Applies To: **2012 Ridgeline** – Check the iN VIN status for eligibility

**Safety Recall: Hazard Switch Assembly With Incorrect “Passenger Airbag Off” Indicator**

Hazard Switch Assembly:  
P/N 35510-SJC-A11ZB

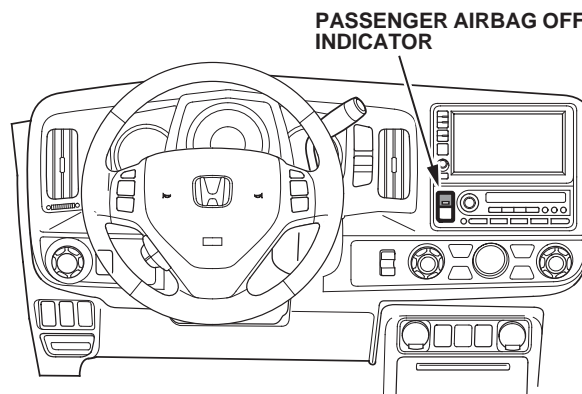
Inspect the passenger airbag indicator, then replace the hazard switch assembly, if needed.

**NOTE:** Since there are only 17 affected vehicles and not all of them are anticipated to have the incorrect passenger airbag indicator, to minimize unnecessary parts demand, only order a replacement switch after you have confirmed that an incorrect switch was installed. You may be able to determine whether a new assembly is needed when the customer makes a repair appointment.
